NEBRASKA CAPITOL ENVIRONS COMMISSION STAFF REPORT

APPLICATION NUMBER	Urban Design Record #26086
APPLICATION TYPE	Certificate of Appropriateness
ADDRESS/LOCATION	1400 K Street
HEARING DATE	August 28, 2026
ADDITIONAL MEETINGS	July 24, 2026
APPLICANT	Travis Barrett, Clark & Enersen
STAFF CONTACT	Collin Christopher, 402-441-6370, cchristopher@lincoln.ne.gov

RECOMMENDATION: APPROVAL OF CERTIFICATE OF APPROPRIATENESS

Summary of Request

Planting Plan

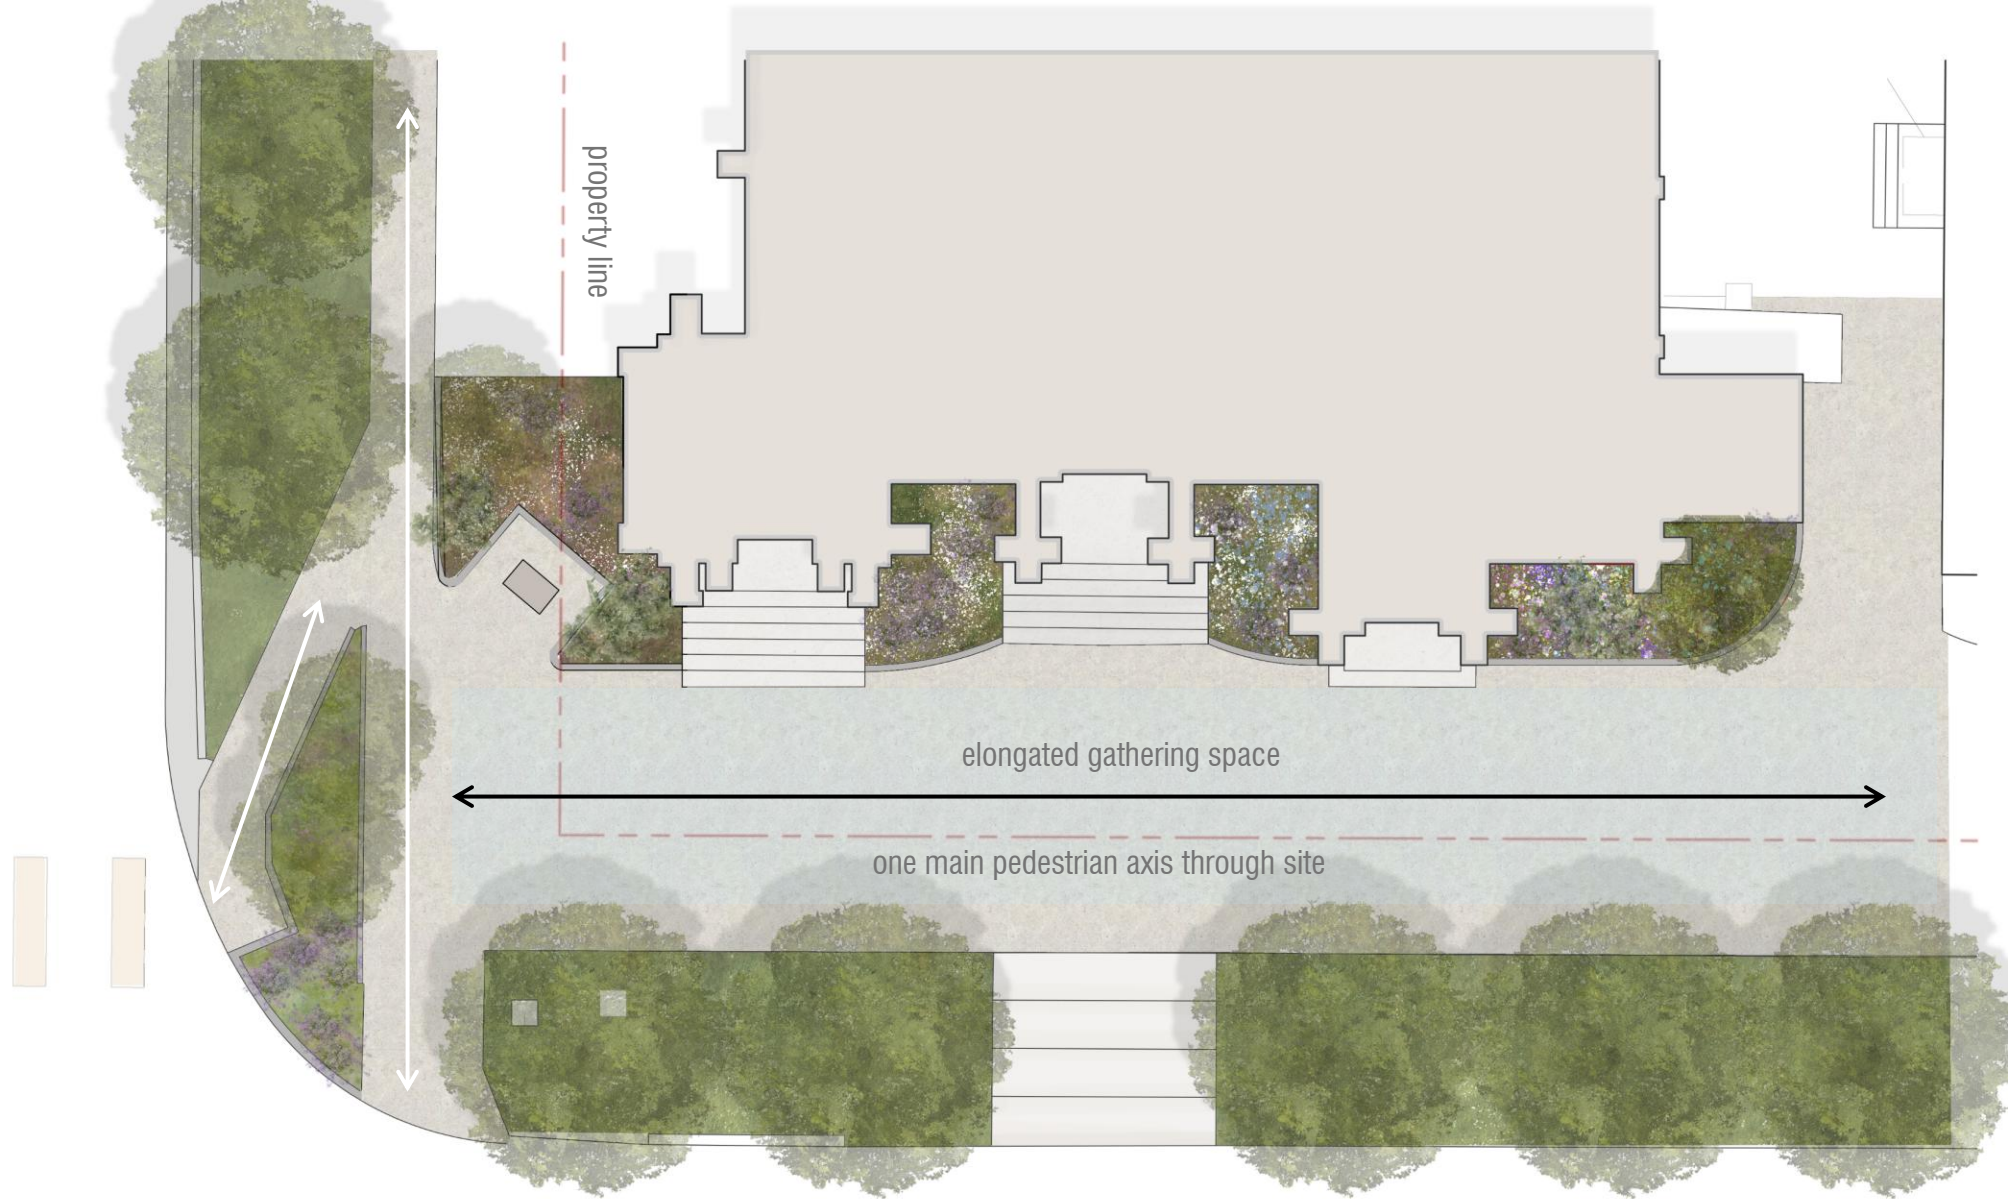
In July, the applicant received a Certificate of Appropriateness from the Commission for the conceptual design of the improvements, with the understanding that final approval would be required as plans were developed further. The Commission asked the applicant to explore the following as they worked through their design process:

- Look at potentially simplifying the planting plan a little.
- Continue to explore the best solution for seating, including the consideration of the best placement and orientation of any seating, the consideration of whether a seat back is needed or not, and the inclusion of skate deterrents in the design of the seating.

The updated proposal in front of the Commission has addressed both of these items in one form or another. The updated landscape plan is in fact simplified, while still maintaining enough diversity to allow for seasonal interest. In addition to a reduced number of plant species, the new plan relies more heavily on woody shrubs and less on perennials.

Regarding the seating, it has been removed from the updated proposal, eliminating the need to discuss this further.

- Simple concrete scoring
- Chamfered planter curb
- Revised plant palette
- No benches proposed
